SERVICE BULLETIN

MW-1 AM Transmitter

AM-099-LAP

Subject: DC Overload Circuit A-18 Board

FIGURE 8-4 AUDIO INPUT AND OVERLOAD, A18, SCHEMATIC 839 1157 001

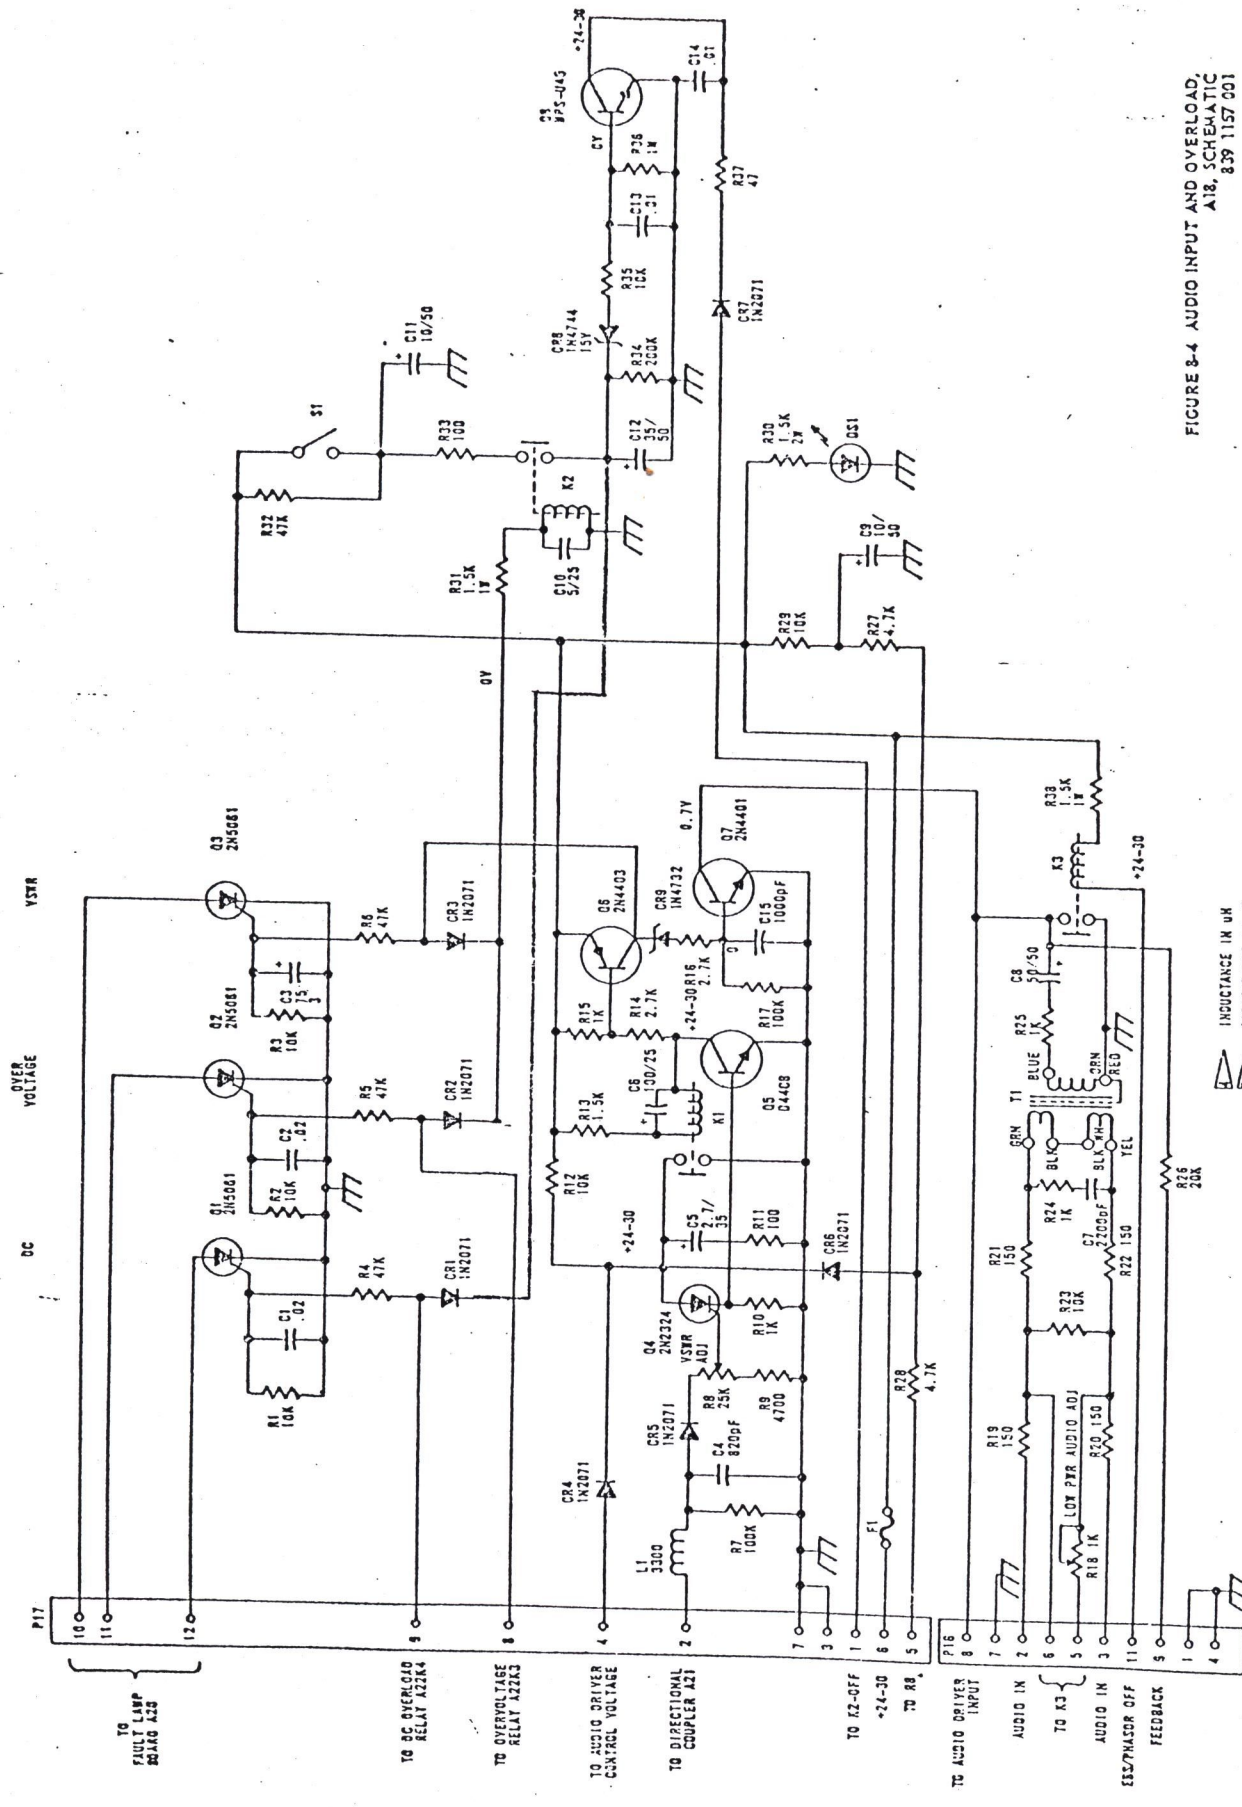
On the "audio input and overload board" (A-18), lift the cathode side of CR1 (where it joins CR2, CR3 and R31) off the board, connect a short insulated wire from lifted side of CR1 to the positive side of C12.

The board should be removed from the transmitter when making change to prevent heat damage to printed circuit board strip.

After change is completed to test circuit, attach jumper wire from Fuse F-1 and momentarily touch the other end of jumper to positive side of CR1. Transmitter should shut down and DC overload indicator should light.

This change will cause the transmitter to trip off immediately in case of DC overload due to any serious component failure.
